DECLARATION FOR THE
EXPLANATION OF SIGNIFICANT DIFFERENCES

South Municipal Water Supply Well Superfund Site
Peterborough, New Hampshire

**RESPONSIVENESS SUMMARY FOR THE EXPLANATION OF SIGNIFICANT DIFFERENCES
FOR THE SOUTH MUNICIPAL WATER SUPPLY WELL SUPERFUND SITE
February 3, 1997**

Figure 1

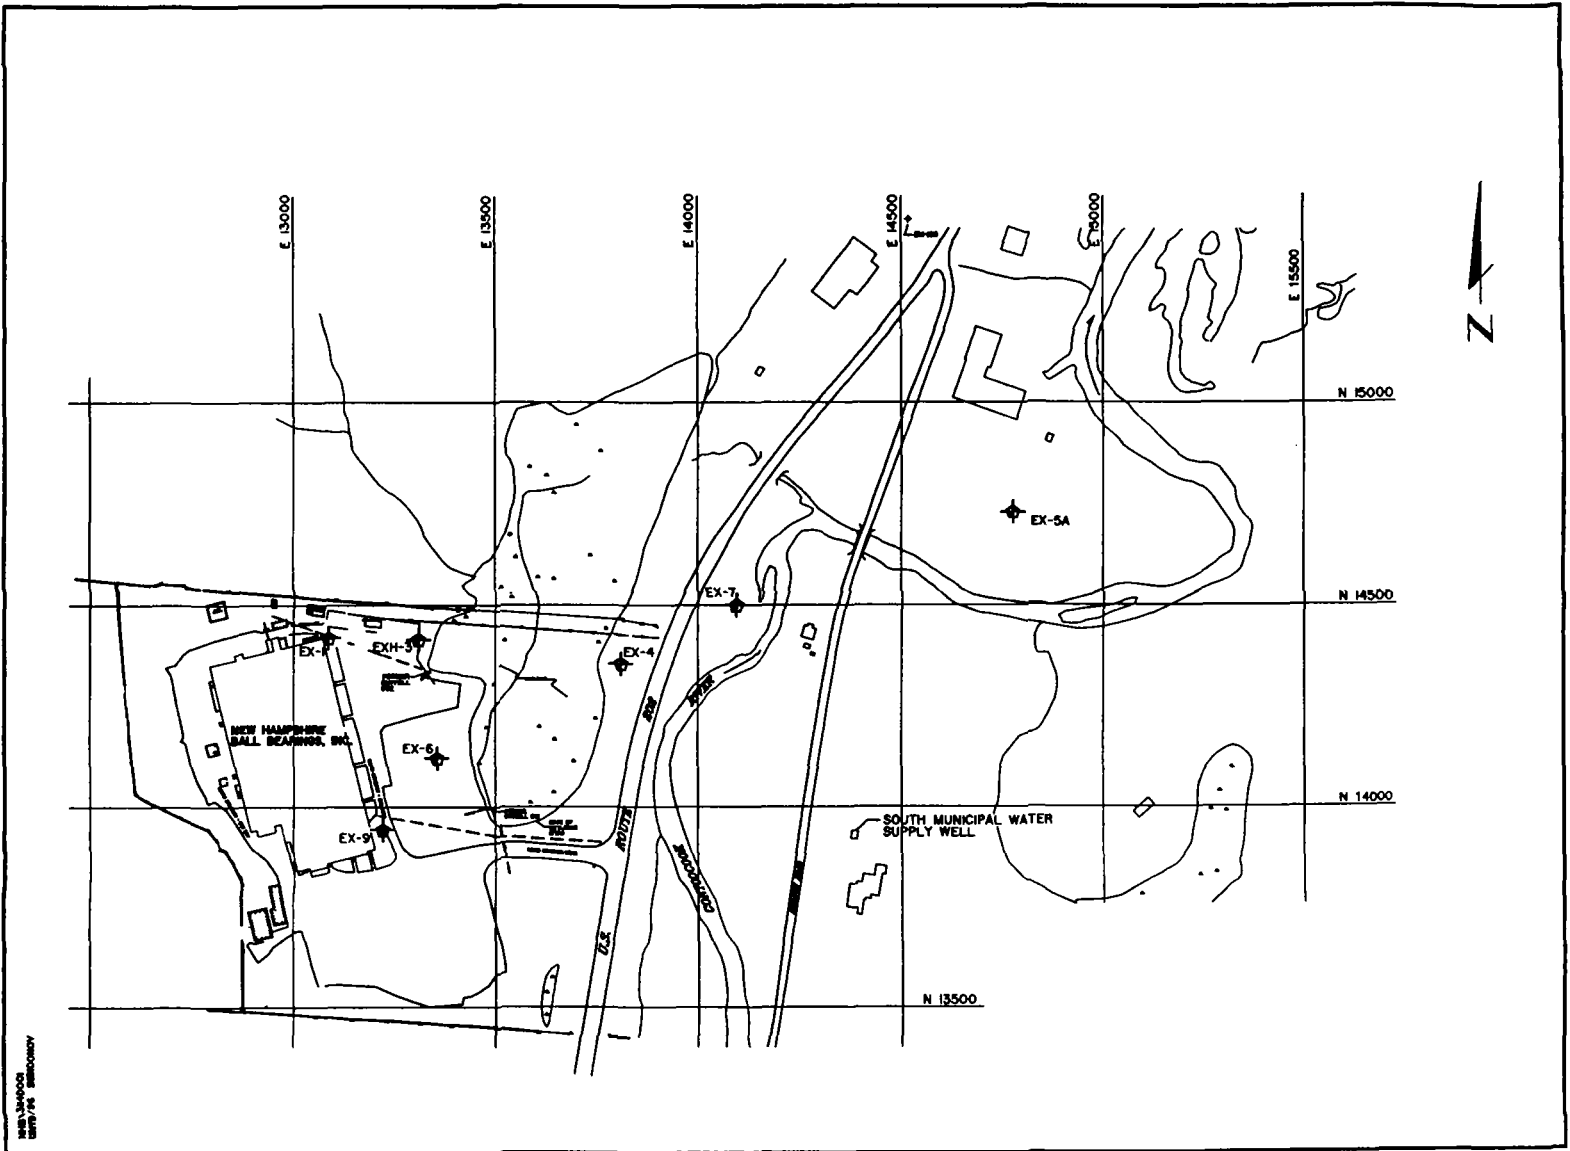
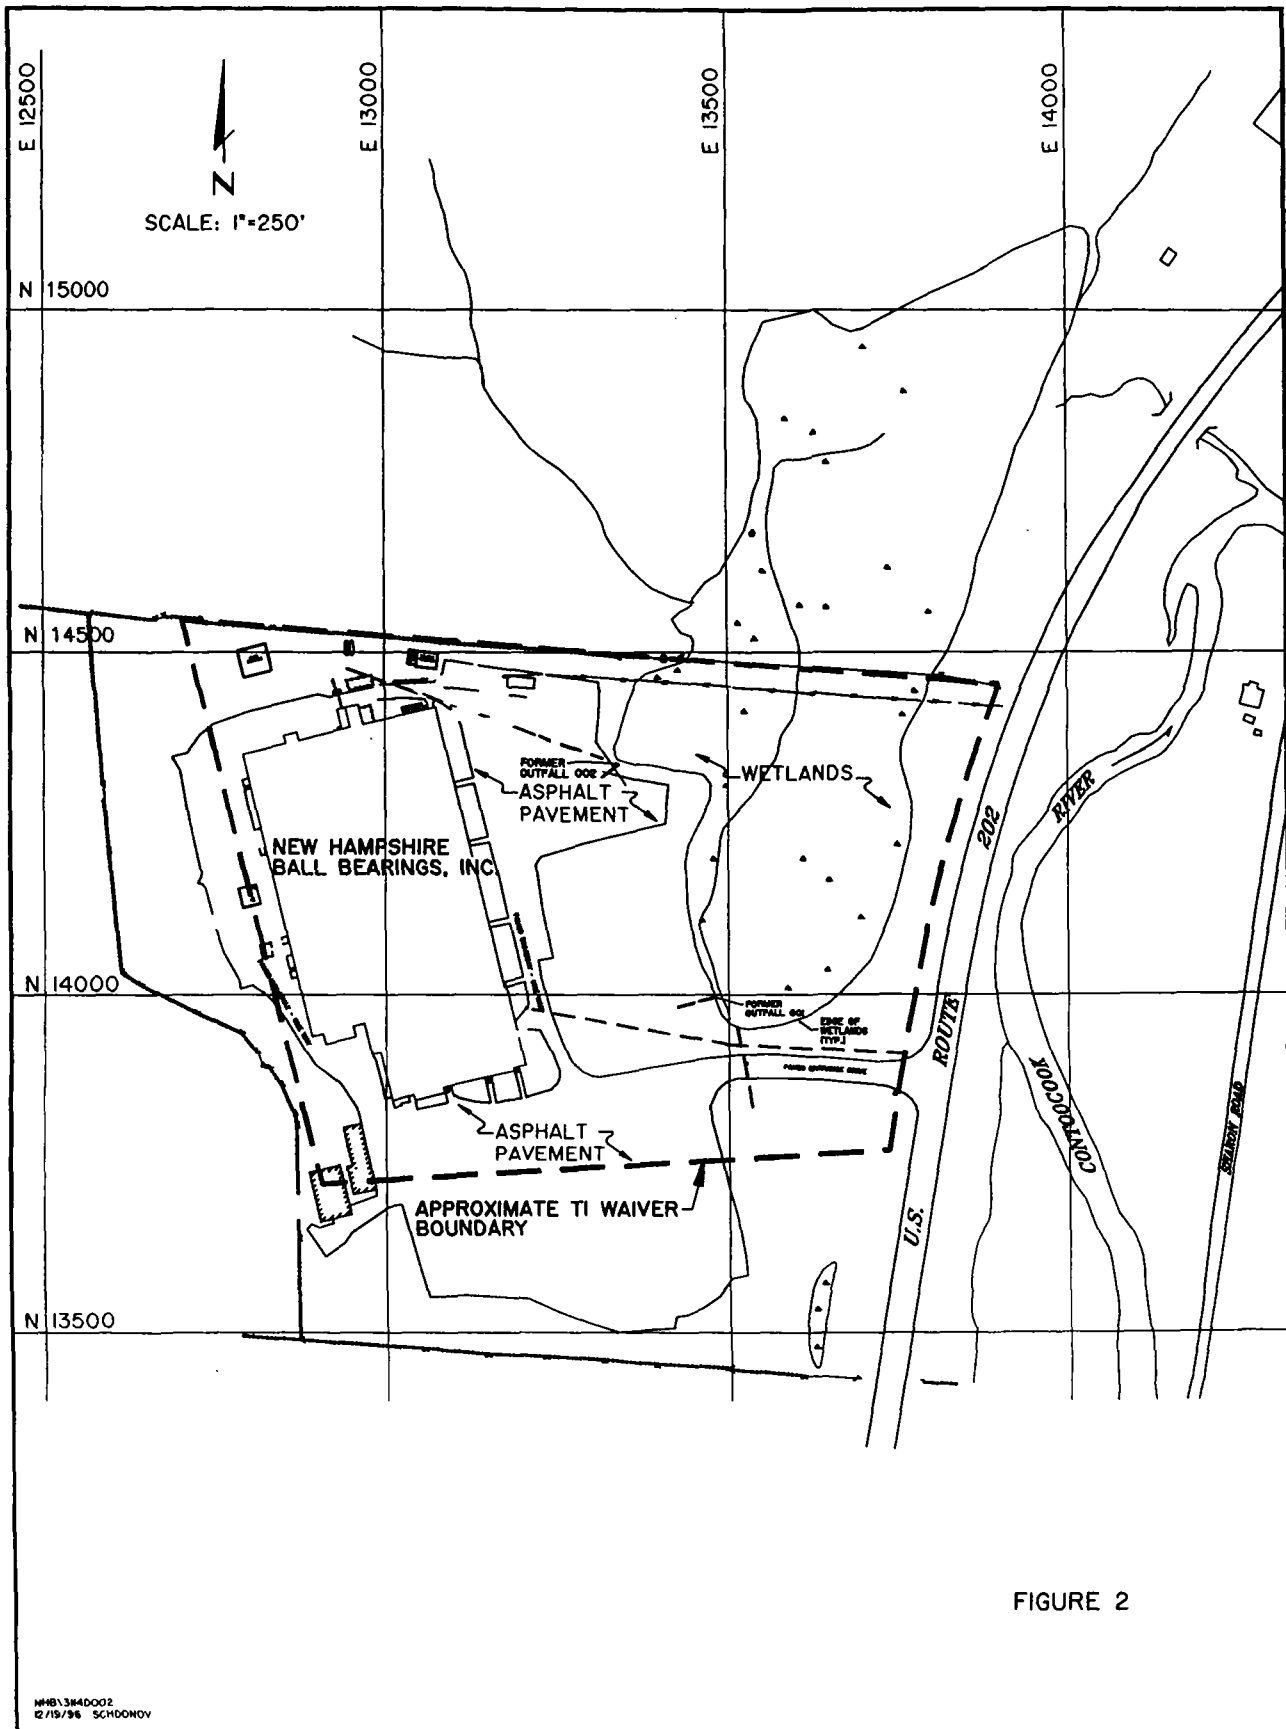
1. Comment: NHBB pointed out that the eastern boundary of the TI Waiver area should extend to the eastern limit of the property (Lot 22 of the Peterborough R-3 Tax Map) controlled by NHBB. This would place the eastern boundary fifty feet to the west of the centerline of Route 202.

2. Comment: NHBB notes that the discussion of the "NHBB plume area" and the "dilute plume area" causes confusion since the TI Waiver area overlaps a portion of the dilute plume area. The TI Evaluation indicates that the dilute plume area can be fully restored, however.

Response: This was EPA's intent. EPA has adjusted the boundary in the ESD and TI evaluation.

Response: EPA acknowledges the confusion and has modified the text in the ESD and in the TI Evaluation and included the "Figure 1" provided by NHBB which eliminates the plume designations.
